EVALUATION OF DOD WASTE SITE GROUNDWATER
PUMP-AND-TREAT OPERATIONS

Report Number 98-090

March 12, 1998

SUBJECT: Evaluation Report on DoD Waste Site Groundwater Pump-and-Treat
Operations (Report No. 98-090)

**Figure 1: Number Of Pump-And-Treat Systems
Becoming Operational By Year (75 of 78)**

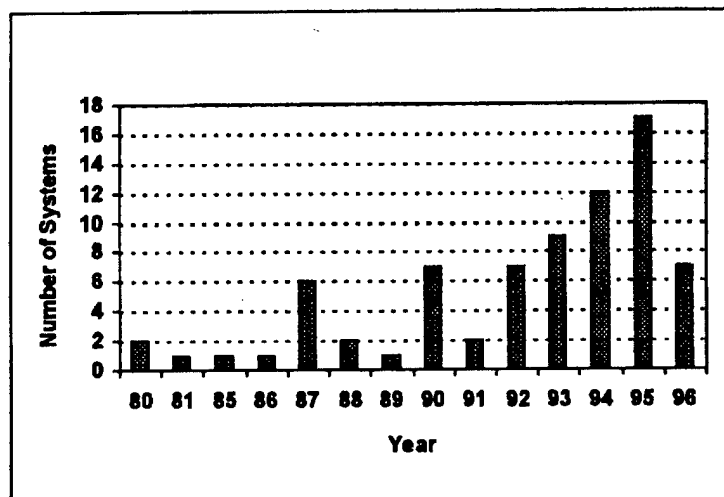
j. Page 6, Figure 1. The report should note that permeable reaction walls (PRWs) using zero-valent iron were first applied in the 1995-1996 time frame. PRWs are probably the most promising technology for removal of chlorinated solvents such as TCE in shallow ground water. Note that the number of pump and treat systems put into operation in 1996 is significantly lower than in 1995, perhaps an indication of the more widespread acceptance of alternative technologies in the mid-1990's.

On page 5 of the Draft Evaluation Report, "DoD Pump-and-Treat Systems," in regard to sentence three of the first paragraph, Figure 1 should read "Figure 1 shows the number of systems becoming operational each year." Figure 1 does not demonstrate that few systems are being turned off as currently stated.

Figure 2: Total Annual Operations and Maintenance Plus Monitoring Costs

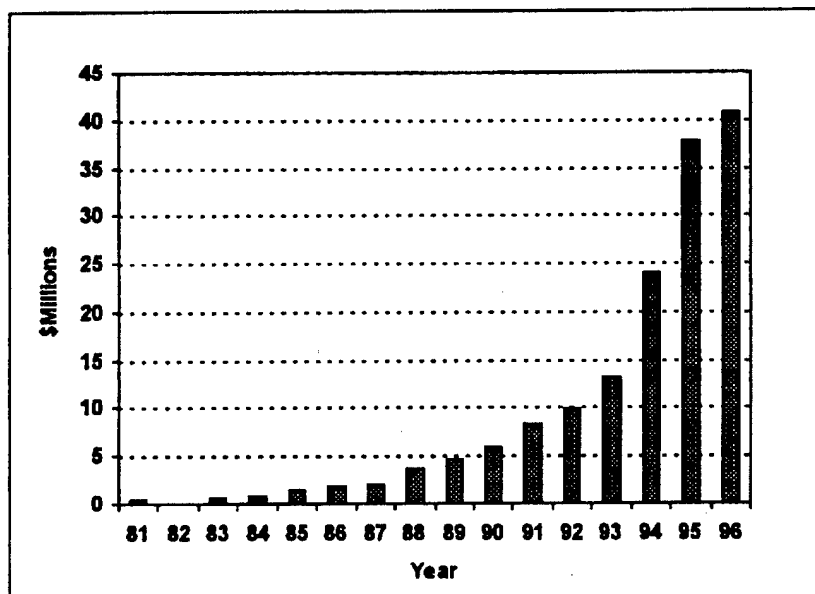
r. Page 10, first paragraph, last sentence. The conclusion reached in this sentence does not necessarily follow from the figure below it. The total costs presented in Figure 2 are a function of the total number of systems in operation. Much of the increase in O&M costs after 1994 is the result of 24 additional systems being brought online in 1995 and 1996. Therefore it is misleading to imply that O&M costs will continue to increase at the same rate as that shown in the figure when the number of new pump and treat systems is declining (only 7 systems brought online in 1996 compared to 17 systems in 1995).
